Appl. No. 09/802,356
Amdt. Dated 03/07/2005
Reply to Office action of 12/09/2004

Amendments to the Drawings:

REMARKS/ARGUMENTS

FIG. 2A

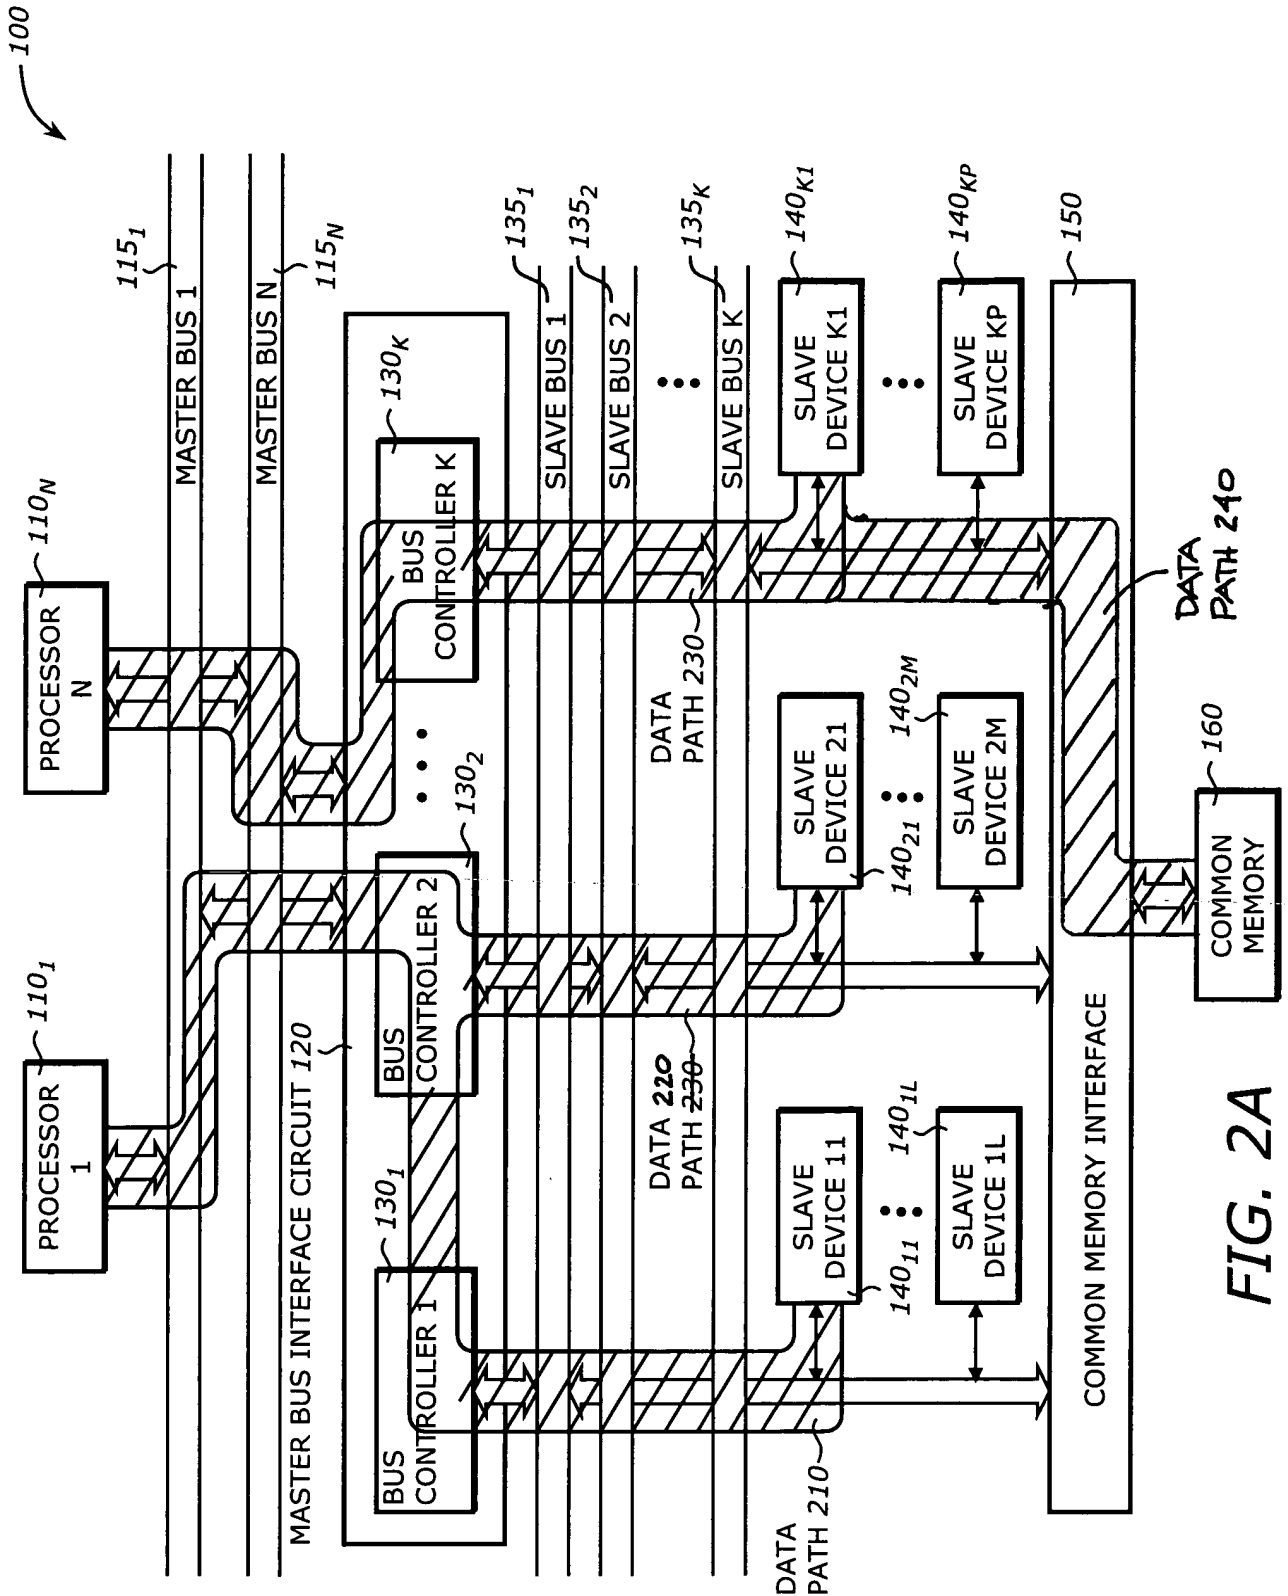
The attached sheet of drawing includes changes to Fig. 2A.

1. The Examiner objected to the drawings due to minor informalities. In response, Applicants have amended the drawings accordingly. The data path 230 is re-numbered 220 and the data path 240 is included. Therefore, Applicants respectfully request the objection be withdrawn.
